NSLPP MEETING HELD ON 04/06/2025

ADDRESS/WARD: 89 Union Street, McMahons Point

APPLICATION No: 397/2024

PROPOSAL: Alterations and additions to an existing terrace house

Figure 3: Proposed Attic Floor

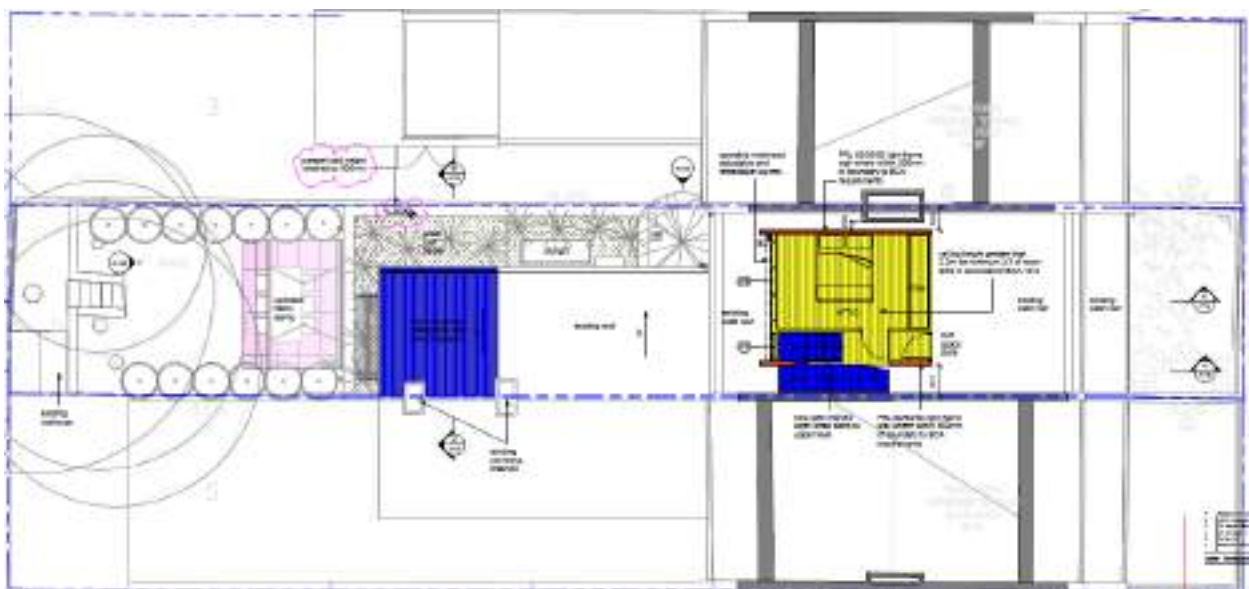
The proposed dormer in the rear roof plane is supported in principle. The western side setback from the party wall is to match the dimensions of the setback on the eastern party wall to improve its fit within the roof plane and with respect to the likely future insertion of similar dormers in the rear roof planes.

Figure 5: Amended West Elevation

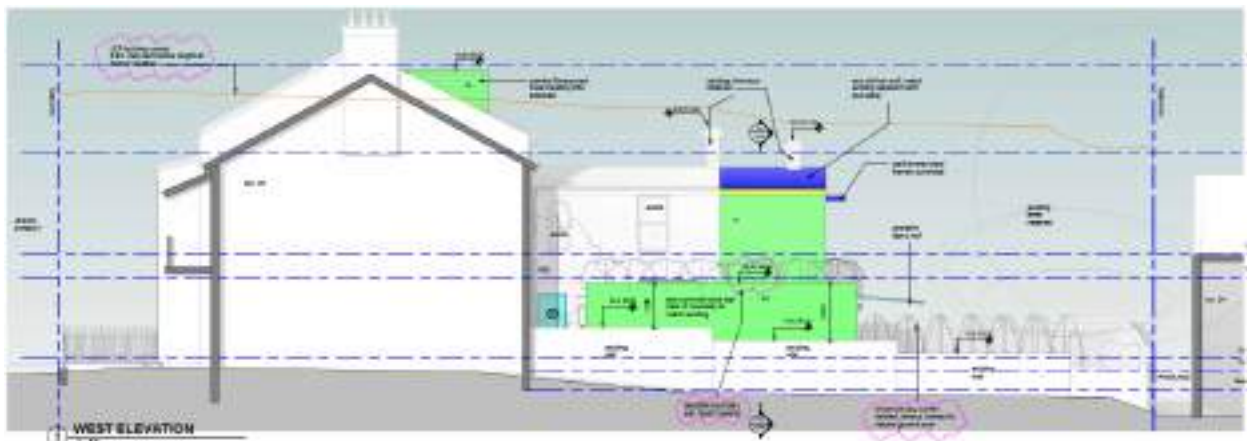
- Amended Architectural Plans to the proposed Ground Floor rear addition at the western side boundary/service wing, which is considered excessive and fails to reinforce the characteristic pattern of setbacks and breezeway orientation within the group of terrace dwellings.
- Amended Landscape Plan with additional detail reflecting the ground levels and existing trees to be retained, and the submission of an arborist report to support this.

- Amended Architectural Plans, Revision F, which retains the 0m western side boundary setback as DA submitted, however, with reduced height of the ground parapet wall and rear ground addition floor level by 600mm (see Figure 5 below).
- Amended Landscape Plan to include new and existing rear ground levels and confirms no change in ground levels in proximity of existing rear trees.
- An arborist report, prepared by ArborLogix, which the existing trees structural and tree protection zones.

Figure 6: Extract from existing floor plans detailing the extent of the kitchen wall and western window to be retained

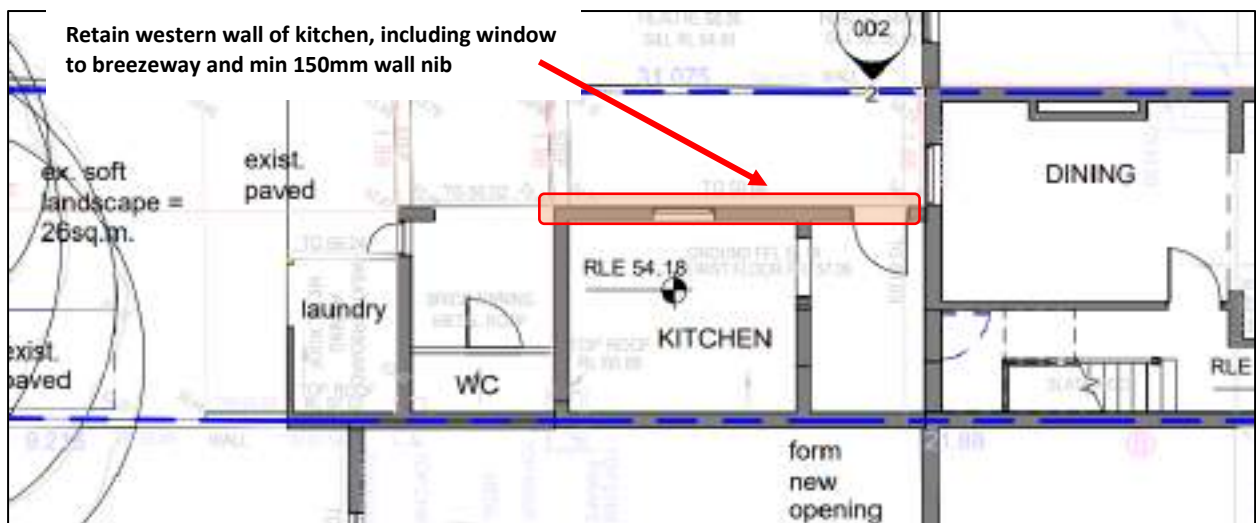
- A5. The following design amendments are required to improve the response to heritage context and to address amenity impacts:
- a) The western wall of the existing kitchen in the rear service wing is to be retained;
 - b) The north facing side window opening of the service wing is to be retained;
 - c) The proposed light court is to be extended to the full extent of the service wing's northern side wall to the point of the proposed living space addition
 - d) The proposed kitchen is to be reconfigured and incorporated into the retained service wing and increase breezeway courtyard;
 - e) A corner wall nib is to be retained, to a width of 150mm, at the north-western extent of the service wing and will serve to reinforce the original heritage character of the dwelling

Fig. 1

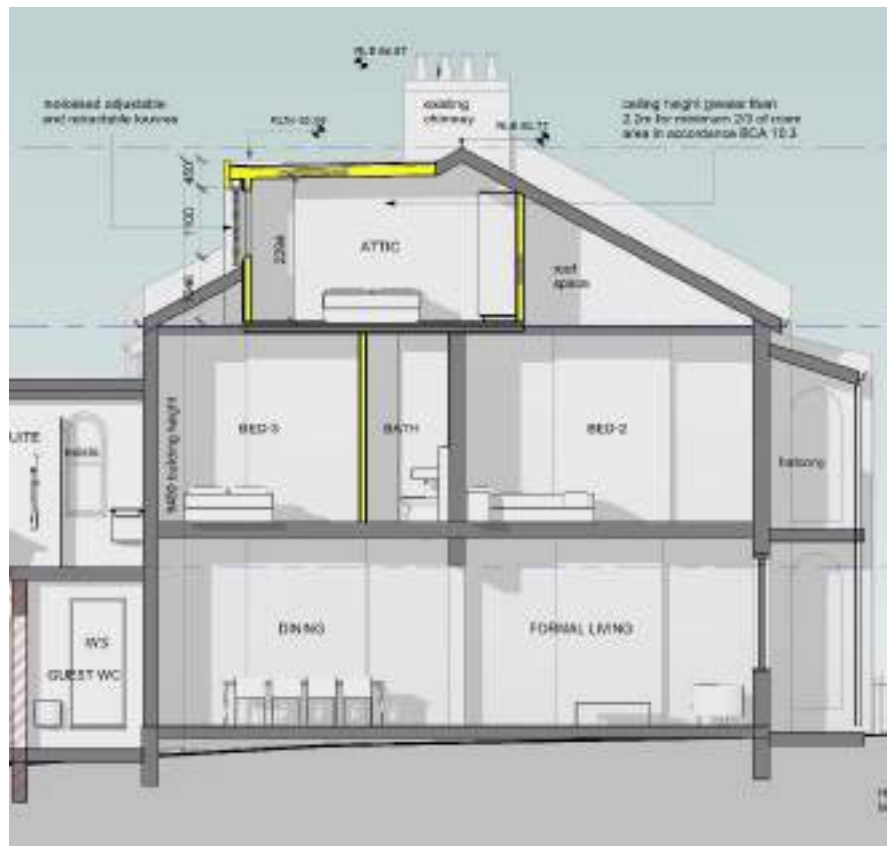
The existing building has a maximum height of 9.7m to the ridge. The proposed eyelid dormer structure will have a maximum height of 9.45m and exceed the 8.5m LEP height limit by 0.95m (11%). As a result of the existing height non-compliance, the provision of eyelid dormer and attic room within existing roof form will be above the LEP height limit (see Figure 1).
